Proposal for amendments to the 00 series of amendments to UN Regulation No. 109 (retreaded pneumatic tyres for commercial vehicles and their trailers)

The text reproduced below was prepared by the expert from the France to amend UN Regulation No. 109-00 Supplement 10, in order to propose a new approval approach for 3PMSF tyres. The modifications are in track change.

Part II.A.

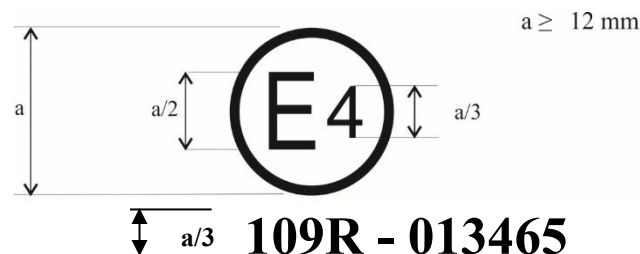
The above approval mark affixed to a sticker of the pre-cured tread packaging that has been approved in the Netherlands (E4) under approval number 109R013465 meeting the requirements of this Regulation in its 01 series of amendments (01).
